Mountain Home Air Force Base Water Resilience Project

Request for Qualifications (RFQ) No. 2023-01

Addendum No. 2

September 21, 2022

Figure 1

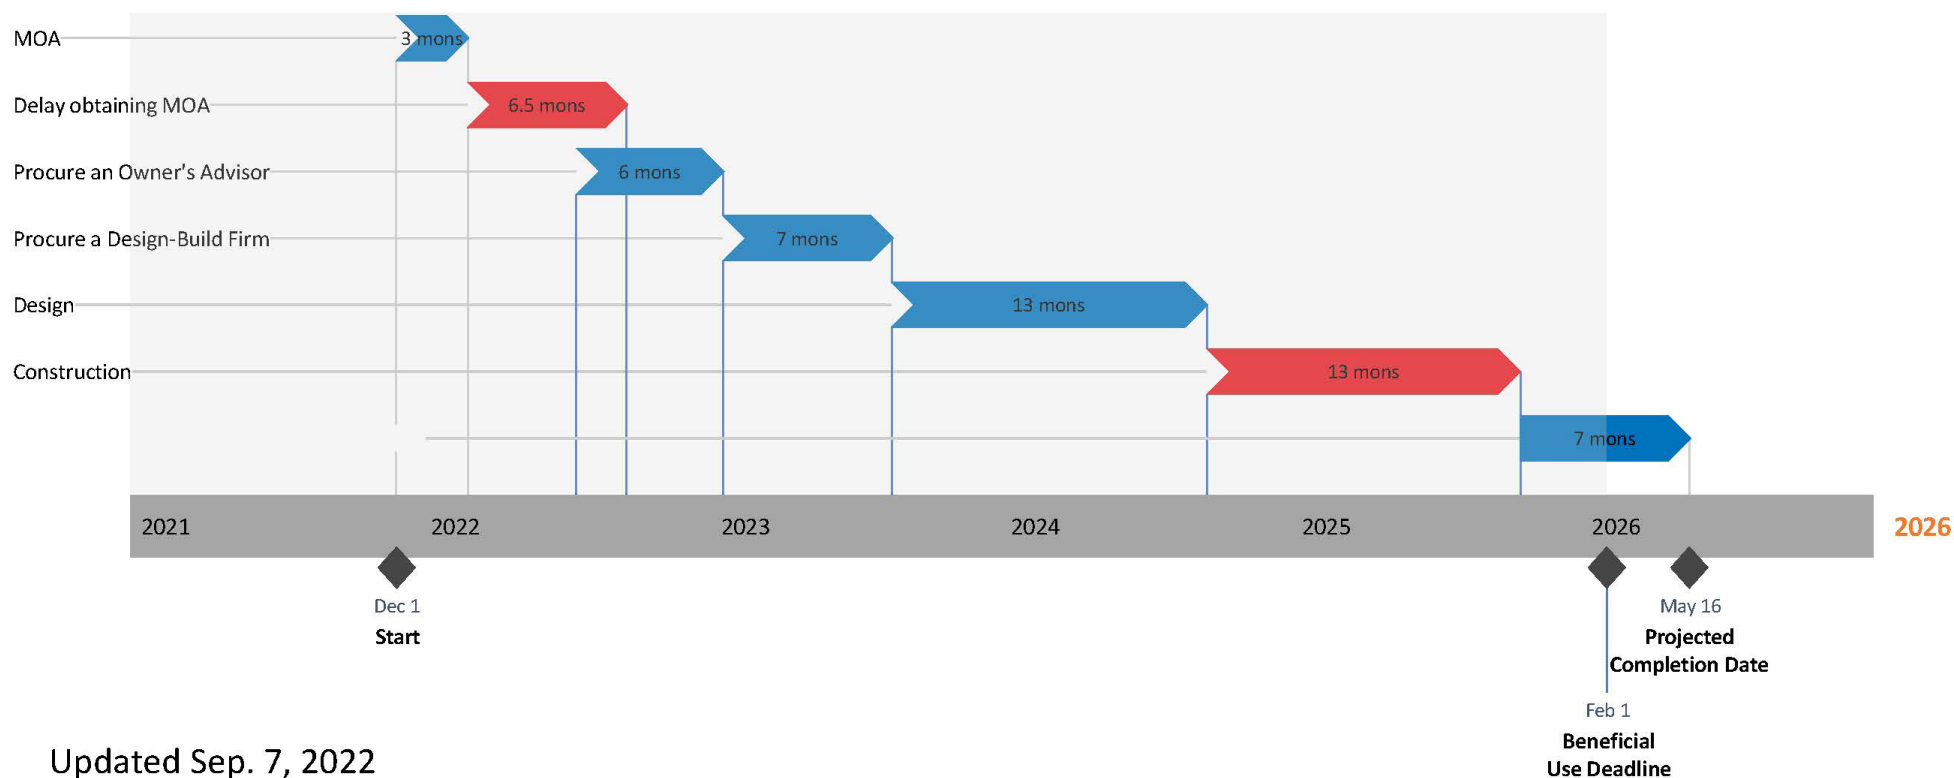
17	What is the preliminary schedule for the DB procurement?	A draft preliminary schedule is provided in Figure 1 of this Addendum No. 2.
18	Can you provide a list of and location of the most current related project/planning documents?	The IWRB webpage provides relevant project information that is available to Respondents. The webpage is located here: https://idwr.idaho.gov/IWRB/projects/MHAFB/
19	Will you provide a list of attendees to the 9/6/2022 meeting?	Yes, the list of attendees is provided in Figure 2 of this Addendum No. 2.
